**SOAH DOCKET NO. 582-20-1895
TCEQ DOCKET NO. 2019-1156-IWD**

**IN THE MATTER OF THE
APPLICATION OF PORT OF
CORPUS CHRISTI AUTHORITY OF
NUECES COUNTY FOR TPDES
PERMIT NO. WQ0005253000**

REMAND PREFILED TESTIMONY

BRUCE I. WILAND

3 A: Yes. I have prepared two, Remand Exhibits PAC-53R BW-2 and PAC-53R BW-3.

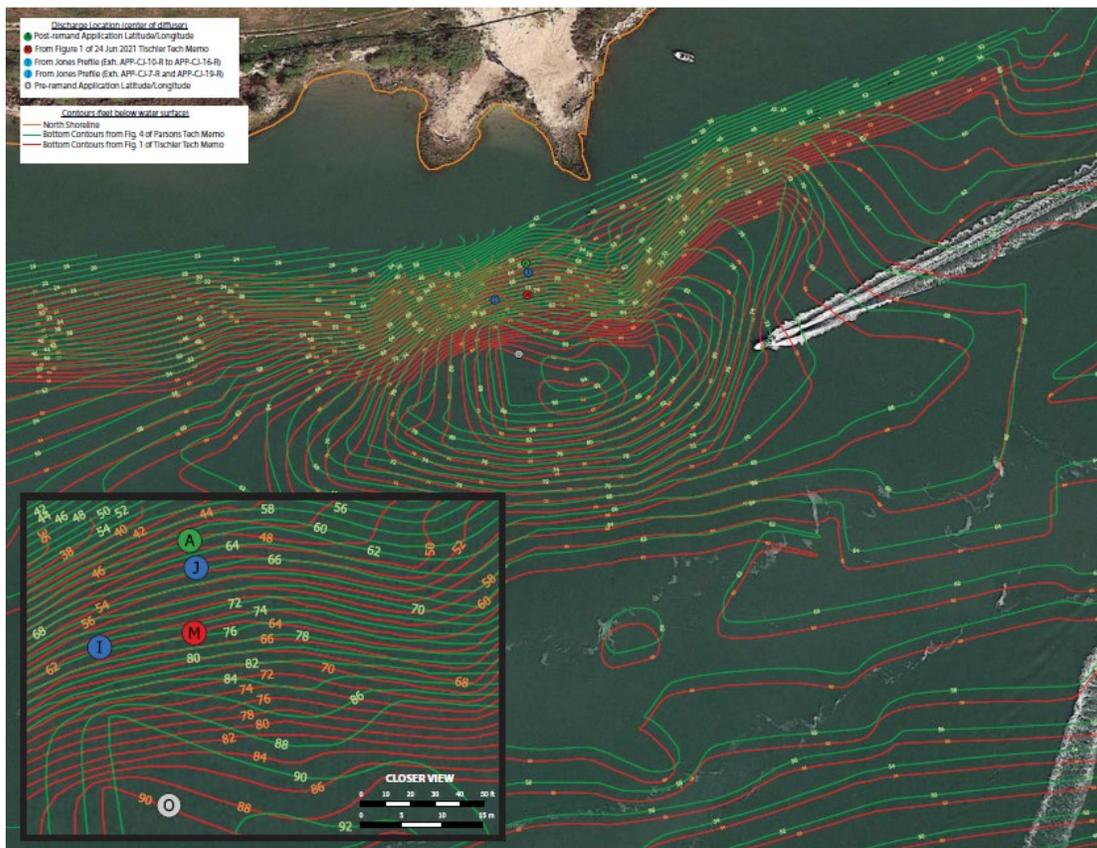
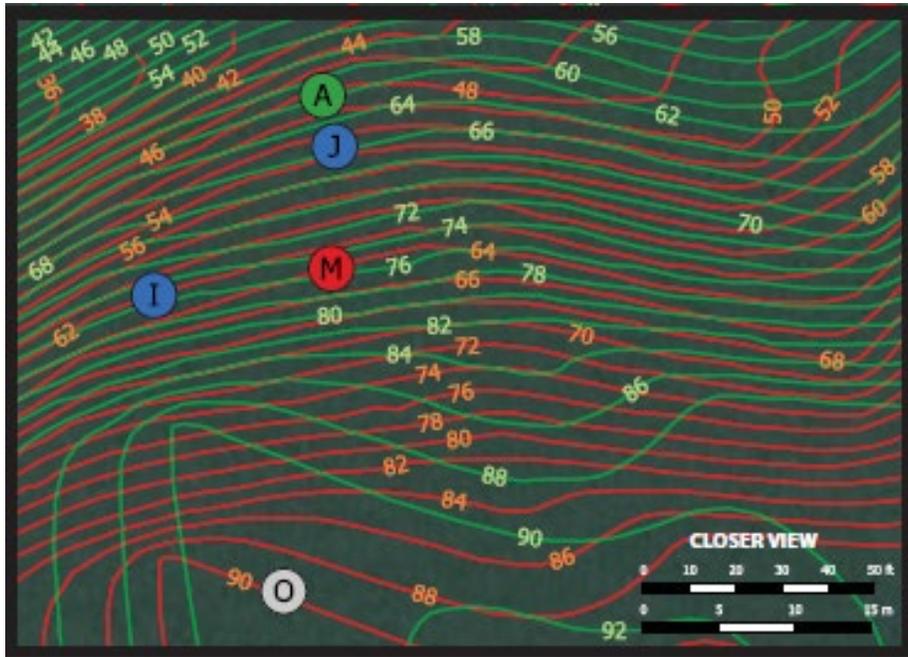
5 A: Remand Exhibit PAC-53R BW-2 (contour comparison) is one I prepared. It depicts the
6 channel floor contours as shown on Figure 1 of Dr. Tischler's memo from the June 25, 2021
7 Amended Application in green (see Admin. Rec. Tab I, p. 00254) and the floor contours shown
8 on Figure 4 of the Parsons Summary Technical Memorandum from the same application in
9 red (see Admin. Rec. Tab I, p. 00185). The background aerial photo which provides the
10 background for the bathymetry in Exhibit PAC-53R BW-2 is the same one as was used in the
11 two figures from the Amended Application.

Q: WHAT IS THE SIGNIFICANCE OF THE SMALL COLORED DOTS AMID THE CONTOURS ON EXHIBIT PAC-53R BW-2, ALSO DEPICTED ABOVE?

A: The dots show the different locations the Port or its witnesses have claimed the discharge point will be located under the amended application. As you can see, the Port and its witnesses have not been consistent in their understanding of the discharge location. Exhibit PAC-53R BW-2 (see, particularly, the inset) shows the discharge location as shown on the Amended Application Tischler Figure 1 map and separately, the discharge location as given by the latitude and longitude in that version of the application. The red dot with the letter “M” represents the discharge location as shown by a filled yellow circle on the map in Tischler Figure 1. This red dot does not correspond to the latitude and longitude location in the Amended Application. The green dot with the letter “A” corresponds to the discharge location as given by the latitude and longitude in the Amended Application. The blue dots with the letters “I” and “J” correspond to the two discharge locations as shown in the Exhibits from Dr. Jones’ direct testimony. Figure 4 of the Parsons Technical Memorandum did not include a discharge location. You can see from Exhibit PAC-53R BW-2 that the locations of the contours are not consistent between the two Amended Application technical memoranda figures and

13 **Q: AND, WHAT DOES REMAND EXHIBIT PAC-53R BW-3 SHOW US?**

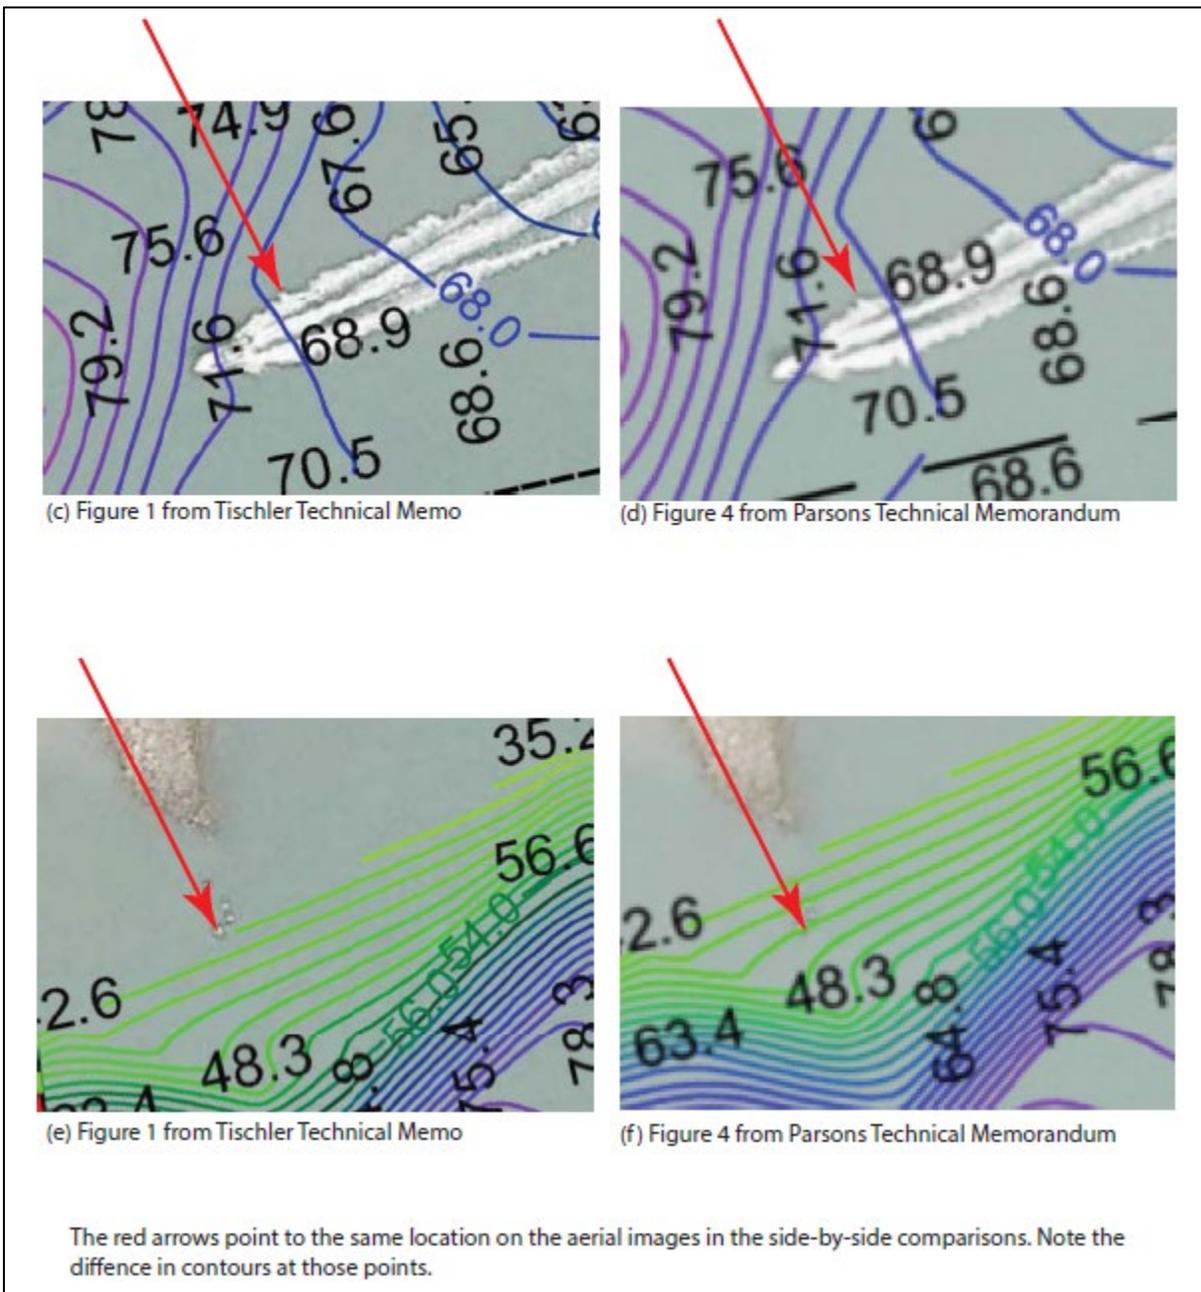
1 that the locations of the discharge points on the Tischler technical memo Figure 1 do not match
2 the latitude and longitude specifications in the Amended Application forms. You can also see
3 the differences in the contour locations in Exhibit PAC-53R BW-3.

6 A: It is my opinion that the green dot is where the discharge is actually located. I think we have
7 to assume that the latitude and longitude figures recited at two places in the June 25, 2021
8 Amended Application are correct. The red contours are the ones that are more consistent with
9 the prior bathymetry prepared by Wood for the POCC's original application and that of the
10 Corps of Engineers. Also, if discharge location "M" and the contours on the Amended
11 Application Figure 1 map are moved in unison so that location "M" is at the correct latitude
12 and longitude, the contours between the two figures come closer to matching.

14 A: Exhibit PAC 53R BW-3 is another exhibit I prepared. It shows identically cropped, aligned,
15 and scaled excerpts from the two June 25, 2021 Amended Application maps that were used to
16 create Exhibit PAC 53R BW-2. This exhibit helps one see that, while the contours in the two
17 application figures have the same basic shape and labeling, the difference in contour locations
18 between the two Amended Application maps is about 34 feet. In the vicinity of the discharge,
19 this corresponds to a difference in depth of about 14 feet. Below are the enlarged depictions
20 from page 2 of Exhibit PAC 53R BW-3, showing that the contour lines do not match up, as
21 shown by looking at the common reference points on each map.
